Access Compliance Report Public Rights-of-Way (Curb Ramps)

Main Street: NEARING_DR Cross Street: FILLMORE_DR Location: SW

ADA ID: RPAT211124134503 Ramp Type: Type 4 - Parallel Initial Pass/Fail: Fail Overall Compliance: No Severity Score: 30

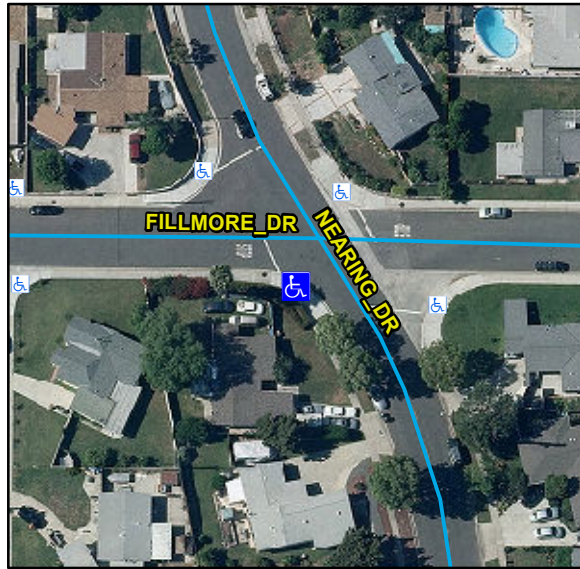
Compliance	Description	Data	Compliance	Description	Data
N/A	Ramp Length LT (in)	117	N/A	Ramp Length RT (in)	111
Yes	Ramp Width LT (in)	54	Yes	Ramp Width RT (in)	48
Yes	Ramp Run Slope LT (%)	3.2	Yes	Ramp Run Slope RT (%)	2.9
No	Ramp Cross Slope LT (%)	5.9	No	Ramp Cross Slope RT (%)	7.4
N/A	Landing Present	N/A	N/A	DWS Provided	N/A
N/A	Landing Length (in)	N/A	N/A	DWS Contrast	N/A
N/A	Landing Width (in)	N/A	N/A	DWS Length (in)	N/A
N/A	Landing Run Slope (%)	N/A	N/A	DWS Full Width	N/A
N/A	Landing Cross Slope (%)	N/A		DWS Offset Type	N/A
N/A	Landing Movement Obstructed?	N/A	N/A	DWS Offset Left (in)	N/A
	Landing Movement Type	N/A	N/A	DWS Offset Right (in)	N/A
N/A	Landing Shared	N/A			
N/A	Clear Space	Yes			
N/A	Clear Space To Crosswalk (in)	N/A			
N/A	Marked Crosswalk 1	No	N/A	Marked Crosswalk 2	No
	Crossing 1 Direction	E		Crossing 2 Direction	N
N/A	Marked Crosswalk 1 Width (in)	N/A		Marked Crosswalk 2 Width (in)	N/A

N/A	Ramp Inside Crosswalk 1	N/A	N/A	Ramp Inside Crosswalk 2	N/A
	Crossing 1 Slope (%)	6.7		Crossing 2 Slope (%)	4.8
	Crossing 1 Cross Slope (%)	0.7		Crossing 2 Cross Slope (%)	5.5
N/A	Gutter Ponding	N/A	No	Curb Slope	11
Yes	Gutter Lip Height (in)	0		Road Run Slope (%)	1.5
N/A	Gutter Run Slope (%)	N/A		Road Cross Slope (%)	8
N/A	Gutter Cross Slope (%)	N/A	Yes	Perpendicular Joint Present	Yes
Yes	Overall Surface Condition	Acceptable			
	Cross Gutter Present?	No		Spandrel Present?	No
	Replace Cross Gutter?	N/A		Replace Spandrel?	N/A

Remove & Replace Curb Ramp With Two New Directional Ramps or Equivalent.
